REVISED RESPONSE TO REQUEST FOR ADDITIONAL INFORMATION

APR1400 Design Certification

Docket No. 52-046

RAI No.: 355-8438
SRP Section: 09.05.04 – Emergency Diesel Engine Fuel Oil Storage and Transfer System
Application Section: 9.5.4
Date of RAI Issue: 12/28/2015

Schematic Diagram of Diesel Fuel Oil Storage Tank HVAC System

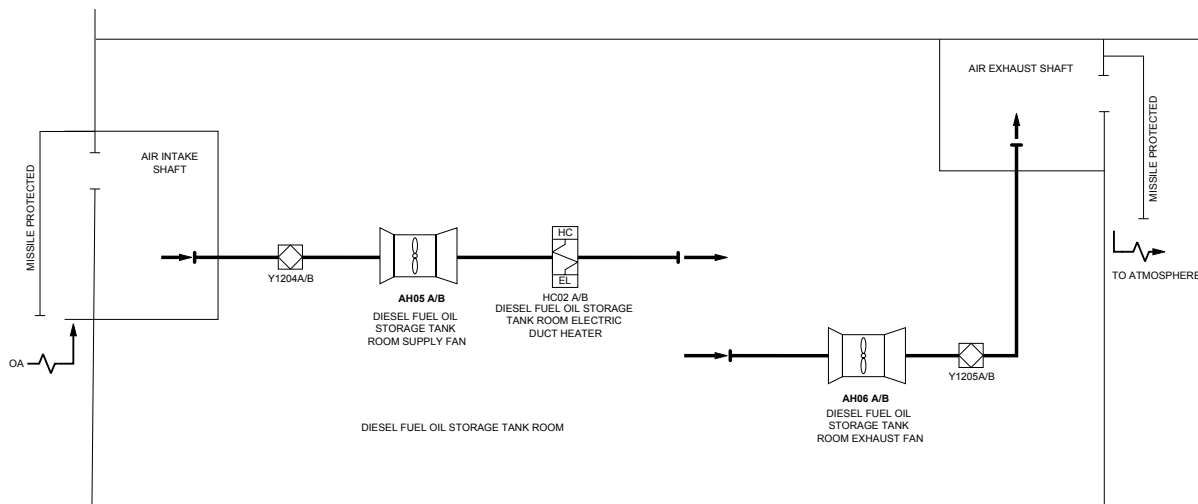
In the APR1400 design, the diesel fuel oil storage tanks and associated piping are located in vaults, which have dedicated HVAC systems as described in DCD Tier 2, Subsection 9.4.5.2.1.3. Supply and exhaust fans for the diesel fuel oil storage tank rooms operate continuously to prevent possible accumulation of oil fumes and to provide ventilation during all modes of plant operation. The electric duct heater operates to maintain the minimum required room temperature in the diesel fuel oil storage tank room. A sketch of the dedicated HVAC system is shown below (DCD Tier 2, Figure 9.4.5-1 provides a more detailed drawing of the system).

Therefore, the air condition in the vault does not have higher moisture content than uncontrolled indoor air conditions in plant spaces within buildings.
